DRAWING TITLE
BLDG 2 THIRD FLOOR PLAN - AREA G2

PROJECT TITLE
SLVHCS REPLACEMENT MEDICAL CENTER PROJECT

DATE
February 29, 2012

2AI103-G2

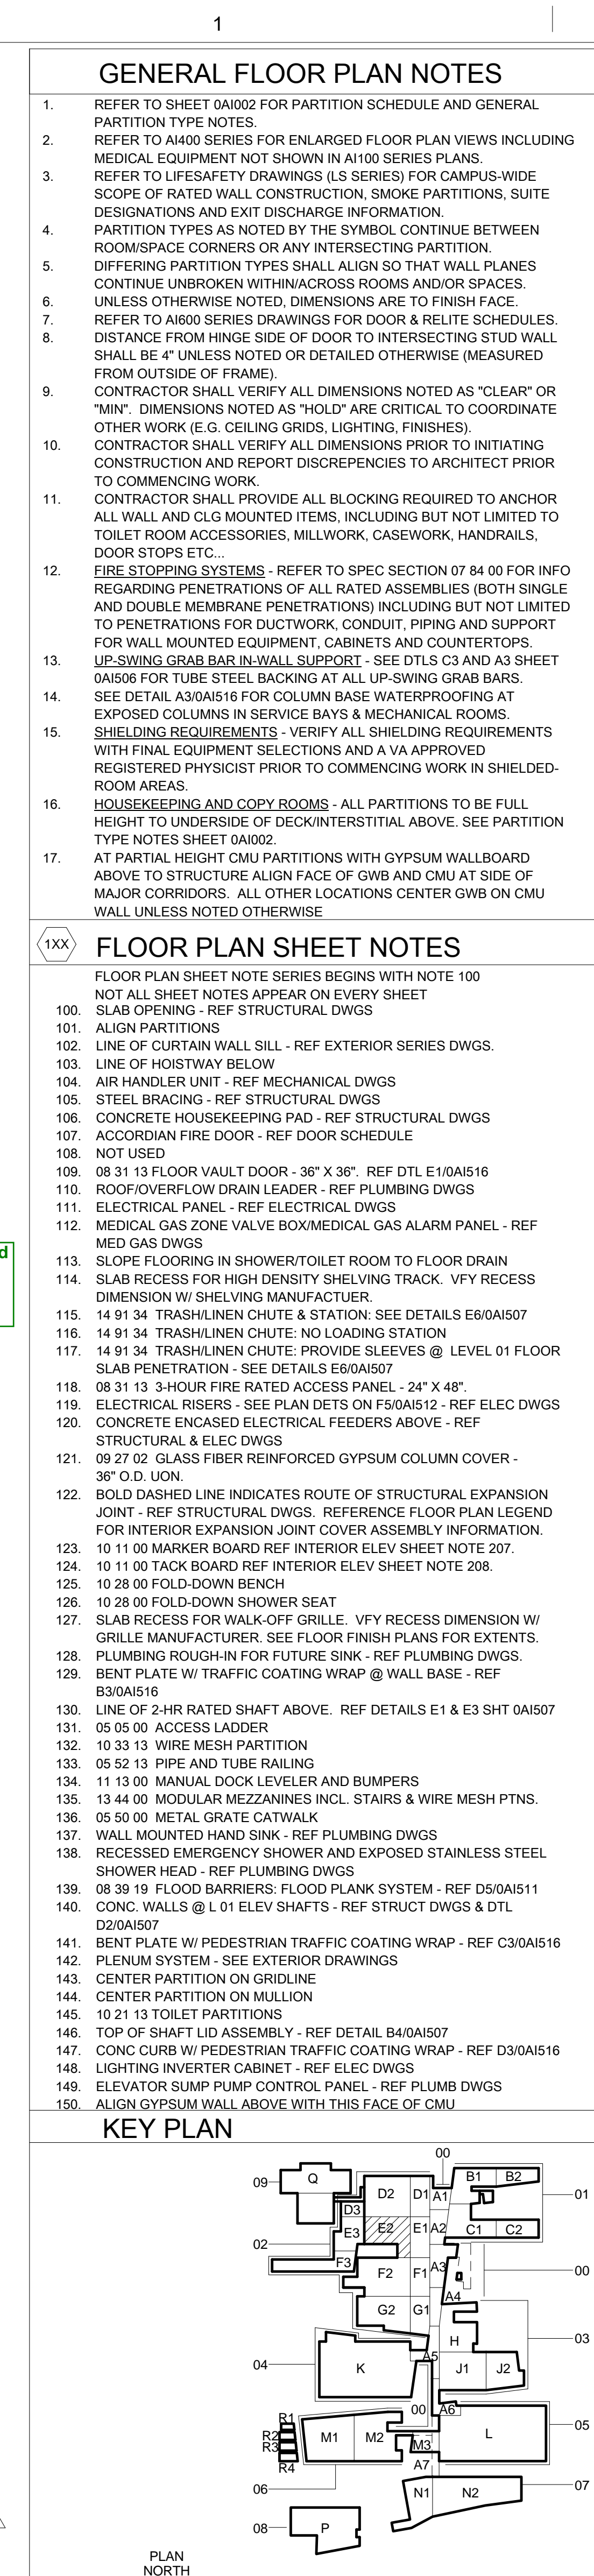
INTERIOR BACK-UP WALL, OPENINGS, SOFFITS, ETC
AROUND PERIMETER OF BUILDING REVISED TO
COORDINATE W/ EWP-06 SKIN COST REDUCTIONS. NEW
AND/OR REVISED PLAN/SECTION/RCP DETAILS AS
INDICATED ON PLANS AND REFLECTED CEILING PLANS.

All noted PD's & CR's on this page were either added, removed, clarified or relocated per RFI 04695

RFI 07212 and 07212.1: All exterior walls where J-4 walls were deleted and more than 3/4" of fire safing is exposed to be handled per RFI.

REFER TO SKETCH: SK-8-1-NJ-2-AI-103-G2-1

RFI 06254: Female Staff Lockers

RFI 02082: A 6AC

RFI 07435: Install D24A or P24A wall and align with electrical closet.

RFI 0584: Shaft wall to be coordinated to fit duct risers

RFI 04422: Marker board 6'-4" from West wall to C/L

RFI 02966.1: TPO

RFI 03037: Fire retardant casework required.

SEE RFI 05314: Shifts wall and sink 20" North to accommodate foot pedals and bedpan washer

SEE RFI 02746 - EXPAND COLUMN WRAP 3" EAST TO ACCOMMODATE 6" GW RISER

REFER TO THE FOLLOWING SKETCH FOR CHANGES: SK-8-4-NJ 2AI003
